# UNITED STATES PATENT AND TRADEMARK OFFICE

10/824,223

<b>Office Action Summary</b>	Application No. 10/824,223	Applicant(s) LIN ET AL.	
	Examiner Zachary M. Pape	Art Unit 2835

## **DETAILED ACTION**

Fig 1

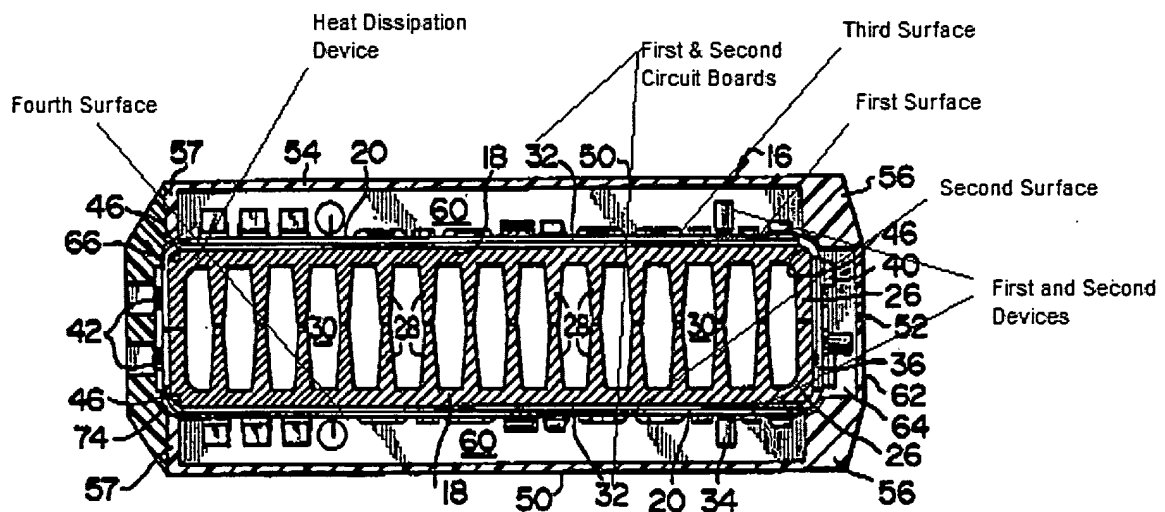
With respect to claim 1, Collins et al. teaches a function module comprising: a first circuit board (32) including a first surface (See present office action Fig 1 below); a second circuit board (32) coupled to the first circuit board (36, 38), including a second surface (See present office action Fig 1 below) facing the first surface; a plate-type heat dissipation device (12), disposed between the first circuit board and the second circuit board (As illustrated in Collins Fig 6). Collins et al. fails to teach a first ground layer formed on a first surface, a second ground layer on a second surface, and that the plate-type heat dissipation device abuts the first and second grounding layer. Nakamori teaches the conventionality of placing first (9) and second (3) ground layers onto respective surfaces on a pair of circuit boards. It would have been obvious to one of ordinary skill in the cooling art at the time the invention was made to place the ground layers (9, 3) of Nakamori on the first and second surfaces of the circuit boards of Collins et al. to provide a heat sink for dissipating heat from the heat generating components on the circuit board and onto the plate-type heat dissipation device (Nakamori Column 3, Lines 64-67).

With respect to claim 15, Collins et al. teaches a function module comprising: a first circuit board (32) including a first surface (See present office action Fig 1 above); a second circuit board (32), coupled to the first circuit board (Via 36, 38), including a second surface (See present office action Fig 1 above) facing the first surface, a plate-

With respect to claims 2 and 17, Collins et al. further teaches that the first circuit board further includes a third surface (See present office action Fig 1 above), opposite the first surface, with a first device (34) located thereon.

With respect to claims 3 and 18, Collins et al. further teaches that the second circuit board (32) further includes a fourth surface (See present office action Fig 1 above) opposite to the second surface, with a second device (34) located thereon.
